PROJECT DESCRIPTION

Property owner Francois Safieddine completed a construction project on the Blue Ribbon Stables Building and the Bussard Building and opened ViewHouse Littleton for business in June, 2017. The properties are located in the Main Street Historic District and an approved COA was in place for the work. However, there are four issues that require resolution in order to comply with the historic preservation code. The proposed COA addresses the four issues and if approved, would supersede the current COA that is in place. The issues are as follows:

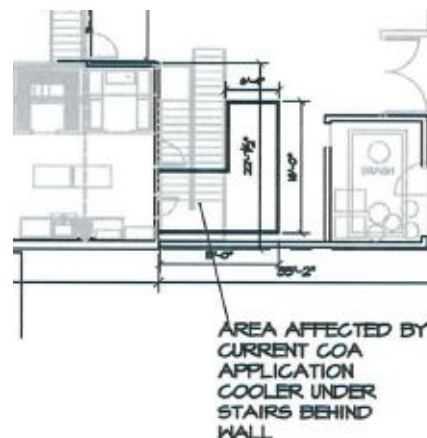
During construction, an I-shaped walk-in cooler was installed at the back of the Bussard Building underneath an exterior staircase to a second-story deck. It is attached to and accessed from the ViewHouse kitchen. The cooler and its screening were not shown on the approved COA. The proposed COA seeks approval for this addition.

← The cooler is located on the west end of the rear patio, between the trash enclosure and the building. See the detail below and *Design Sheet 6*.

2016_approved COA with no outsider cooler shown

2017 COA application with outside cooler shown

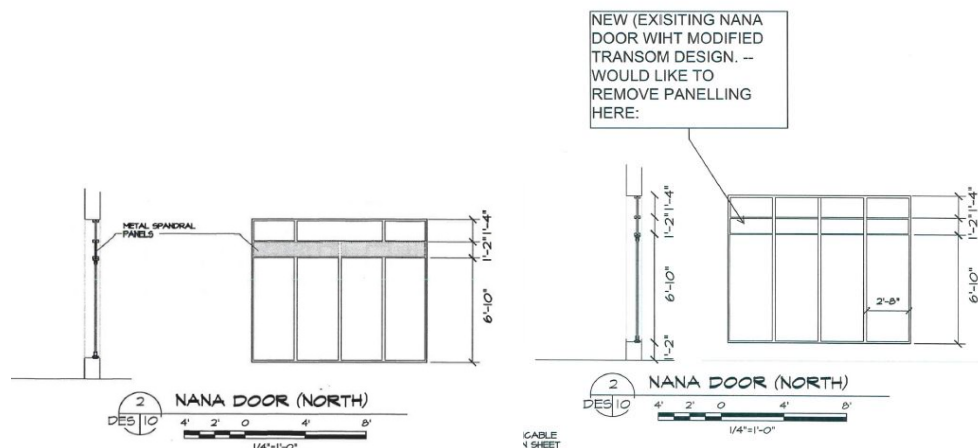
The design and construction of the Nana windows at the front of the Bussard building were modified during construction in response to issues with the original design, as it was approved by the 2016 COA. The original design was to have the lower windows open and the upper windows be fixed. The two sets of window would be separated by a structural transom. The window fabricator determined that the transom element would not be strong enough to support the Nana windows below. As a result, each vertical division of windows is now a single vertical element that is supported from the top of the window frame. The other result of the shift was to line up the muntions. The applicant is seeking approval of the modification with the current COA application.

On the left are the Nano doors approved and installed per the 2014 COA. The 2014 windows had three fixed transom windows above, a continuous transom between the upper and lower windows, and four Nano windows below. Because the window fabricator was concerned that the lower windows would not be well supported by the continuous transom, the windows were redesigned to be single windows that extend from the top of the window frame to the bottom of the frame. As a result, there are now four divisions across the top and four across the bottom. The perceptible form of the new windows is intended to be transom windows on top, a continuous transom between, and separate windows below. The middle windows were fabricated with both glass and metal inserts. The 2017 CIA application asks which of the two options is more consistent with the COA criteria.

The Nana windows are currently installed without the metal “transom” inserts.

The applicant prefers to leave the panels off the transom windows to provide more light to the interior.

Staff believes that the metal transom panels are necessary for the windows to best meet the design guidelines, which call for the new design to “Preserve the character-defining elements of a traditional storefront.” With the metal transom panel inserts, the form of the upper windows bears a much stronger resemblance to the traditional transom windows.

3) FIRE ACCESS LADDER AND SAFETY RAIL

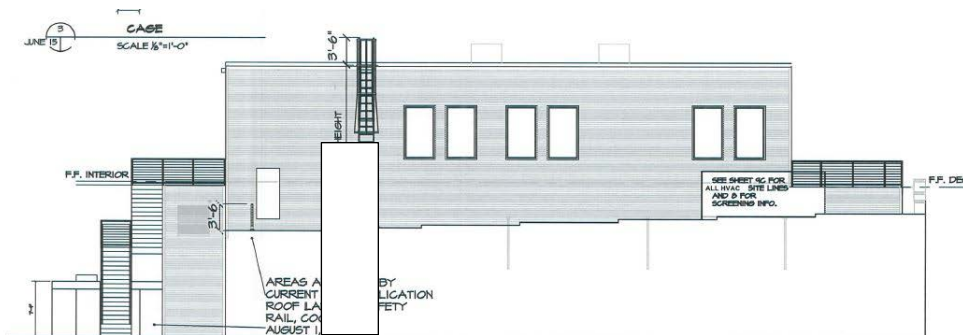
The city fire code has mandated that the contractor install an access ladder to the roof of the second floor. The ladder was not anticipated in the 2016 COA and was not included in the building permit plans. The ladder is proposed to be located on the east wall and will provide access to the roof of the second floor addition from the roof of the first floor.

4) HVAC SCREENING (ALSO LABELLED AS RTU ON THE PLAN SET)

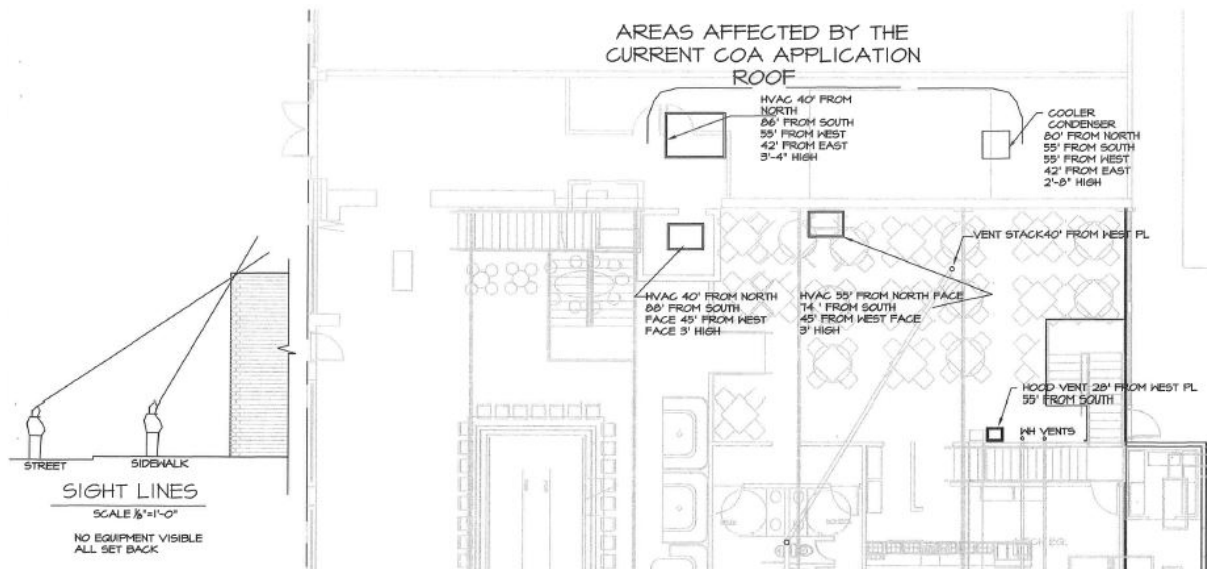
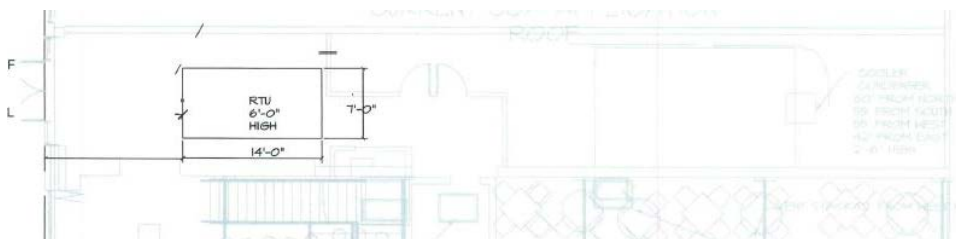
The approved COA plan set showed the HVAC unit to be 40 feet from the north face of the building. At this setback, it was demonstrated to be out of site from the sidewalk across Main Street, meeting the standard in the Downtown Design Guidelines and Standards. However, the plan set submitted with the building permit application was approved with a 13-foot setback from the north face. As such, the location of the HVAC has been approved. In order to be in compliance with the historic preservation code, however, it must be screened or an acceptable alternative must be approved, per applicable design guidelines.

The approved 2016 COA showed the northernmost HVAC unit as 40' from the north wall and 3-4' high.

The current location of the HVAC unit, as shown on the 2017 COA application

Engineering discoveries during construction resulted in the largest HVAC unit being placed 13' from the north wall, rather than 40' as approved in the 2016 COA. The HVAC unit is also 6' tall, rather than 3-4' tall, as indicated on the approved 2016
